**Site Address: 2751 WEST RIVER DR SAC St: BLD#20**  
Parcel No: 274-0440-001 BLDG. #20

**Nature of Work: BLDG. # 20, TYPE A, NEW APT. WITH GARAGES**

**Architect's  
 Supplemental Instruction No. 00007**

Date: 8/20/2003  
 Project Name: Villas at Riverbend  
 Project Number: 6510001  
 Subject: Clarifications

**Floor/Ceiling Assembly Clarification:**

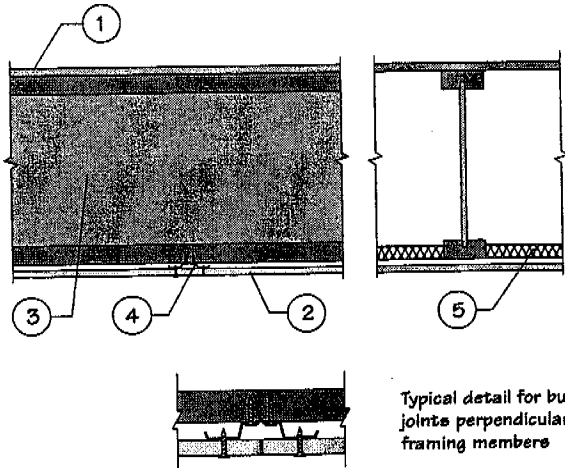
Test # G & H USDA - 11 ST

1-1/2" lightweight concrete (100 p.c.f.) over 3/4" plywood over TJI at 24" with RC channels and one layer 5/8" type x gyp board.  
 3" glass fiber batts insulation required at vinyl floors. STC = 58. IIC = 50 at vinyl. 77 at carpet and pad.

**Roof/Ceiling Assembly Clarification: No STC required**

Test # 2002 CBC, Table 7C - #21

Wood trusses at 24" with 1/2" plywood sheathing and two layers 5/8" type x gyp.  
 Must use two layers gyp even with RC channels for fire rating. (PFC 4354)

### ASSEMBLY F

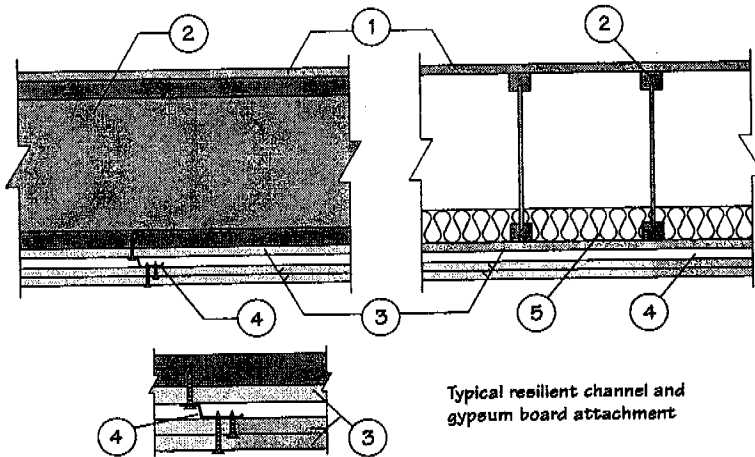
REF: NER-200, ICBO ES PFC-4354

Lightweight concrete or approved gypsum topping with appropriate sheathing can be substituted for the decking material shown in any of these assemblies.

FURRED CHASES @ THE VILLAS.

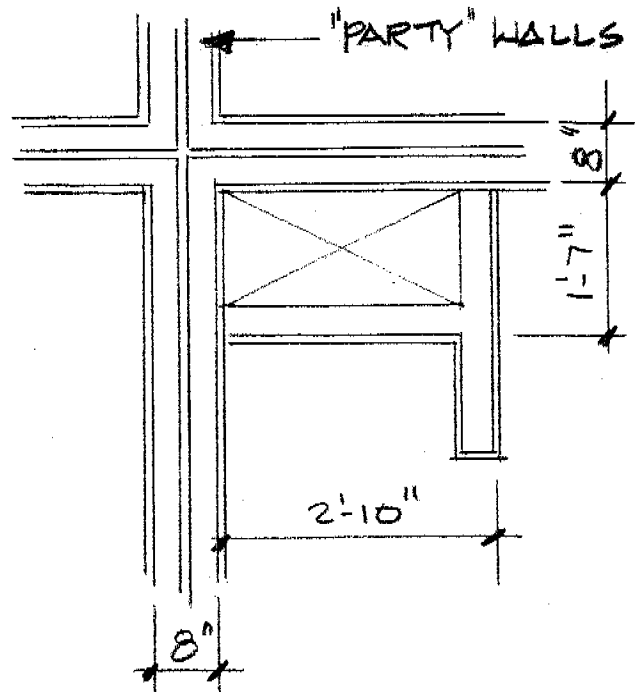
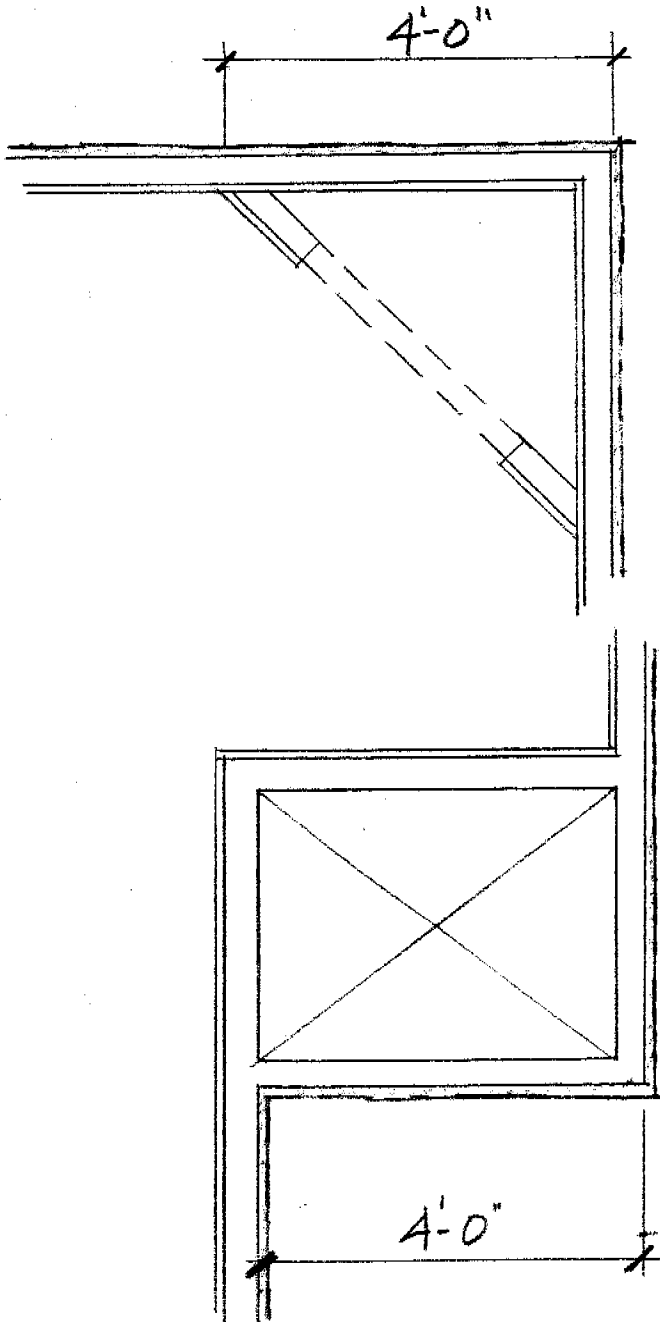
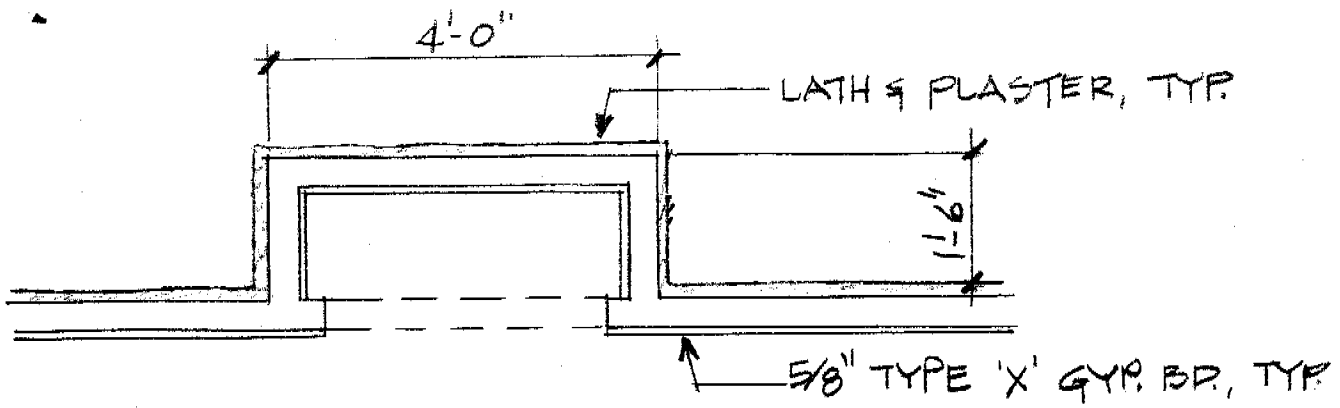
The quick answer is that yes, if the building is a Type V-1 hour building, the walls (interior and exterior) need to be rated based on Table 6-A. They do of course get to use Section 601.5.2.2. That would permit many of the interior walls to be non-rated.

Probably the big thing that would affect/answer your other questions is whether or not it is a "shaft." If the code would require a "shaft" based on 711 (and not covered by 711.3) then it would require sheetrock on both faces of the double walls, but if it is not required to be a shaft (it really is just a "wall") then no, you only need the sheetrock on the outside of the two walls and not on the inside face.

The best thing to look at is in the general explanatory notes in the Gypsum Association's Fire Resistance Design Manual. There are two specific items (items 15 and 17 in the 17th edition). The first says "greater stud sizes (depths) shall be permitted to be used in metal- or wood-stud systems." The second says "within design limitations, the distance between parallel rows of studs, such as in a chase wall, shall be permitted to be increased beyond that tested. When stud cavities in walls constructed of parallel rows of steel studs exceed 9-1/2 inches and cross bracing is required the cross bracing shall be fabricated from steel studs."

Therefore, if a "wall" is OK with 5/8 inch Type X on both sides of a single stud wall, you could either use a 2 x 8 or such for the studs instead of a 2 x 4 and be OK or you could simply move the double stud walls farther apart. For example GA assembly WP5512 shows a double stud wall with a one-inch air space. That space could be increased beyond one-inch without reducing the walls rating. The only caution is the fireblocking issues in Section 708.2.1.

The exterior wall is just considered as a "nonsymmetrical" assembly and the provisions of 709.5 control. They may want to go to UBC standard 7-7 and calculate the rating.
